Re: CAO 15-001, SEP 15-001, VAR 18-002
Containment Wall Requirement

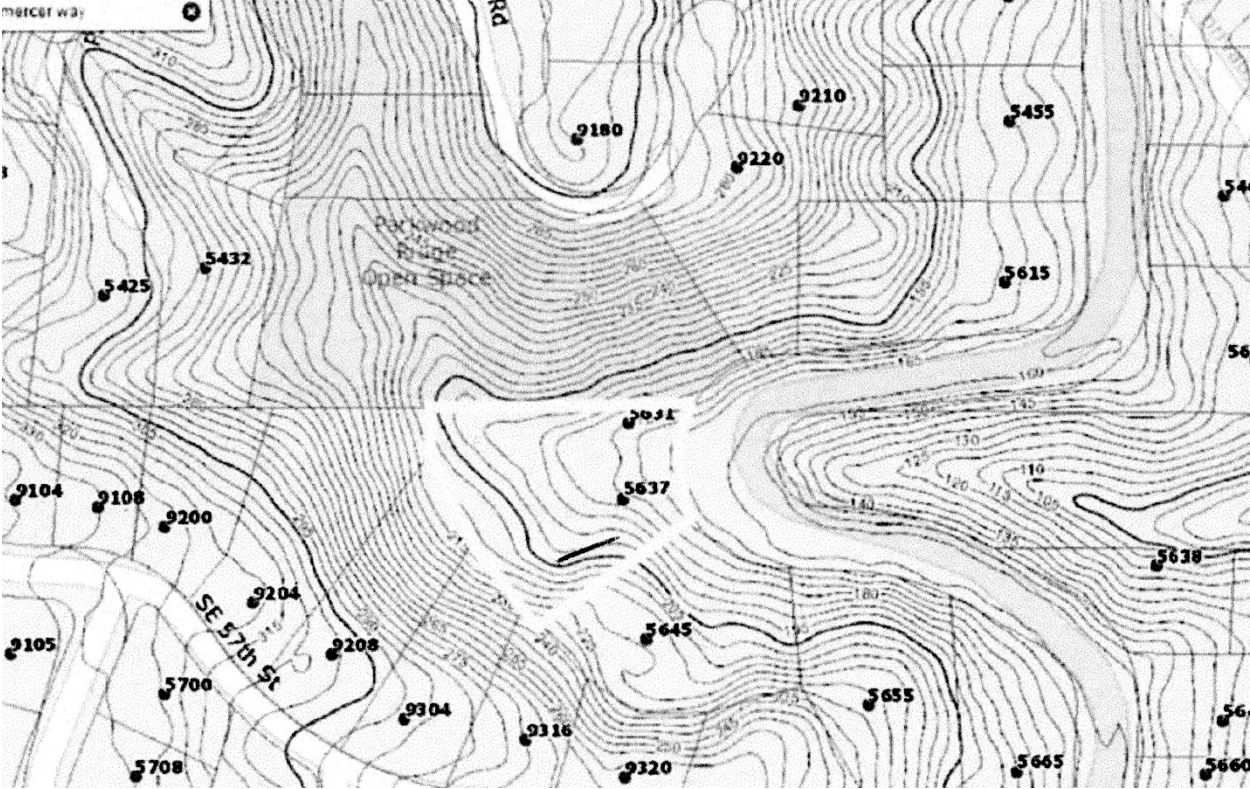
The reference to the "steep slope south and southwest of the proposed residence" is clearly understandable as the steepest slopes are in those directions. This can be seen by the topographic map of the area found in the GEO letter of February 4, 2016, at page 3 and shown below:

The black line superimposed on the map is the approximate location of the southeast wall of the proposed residence. The slope to the southeast of the residence is relatively mild compared to the very steep slopes south and southwest of the residence.

In a letter dated April 27, 2016, GEO refers to a catchment wall being incorporated into the building. However, there is no reference in the letter to the direction in which the catchment wall should be aligned. The GEO letter of October 2, 2015, refers to placing the wall “at or near the base of the steep slope south and southwest of the proposed residence location.” As shown by the topographic map above, the very steep slopes are to the southwest and south of the residence, and **not** to the southeast.

The plan submitted by Treehouse subsequent to the hearing shows a catchment wall built into the southeast wall of the residence facing the slope to the southeast. GEO had originally proposed in its letter of July 30, 2015, a catchment wall for the southeast wall of the residence, but this idea was subsequently abandoned. Rather, GEO recommended that “the wall alignment should run south of the residence **and continue around the southwest corner a distance of another approximately 20 feet.**” [Emphasis added.] Using the southeast wall of the residence as a catchment wall simply does not comply with this requirement. The proposed residence remains exposed to landslides from the steep slopes to the southwest and south of the residence. Aside from the topographic map, one can readily see from a visit to the site that the slopes to the southwest and south of the residence are far steeper, more precipitous, and much higher than the slope to the southeast.
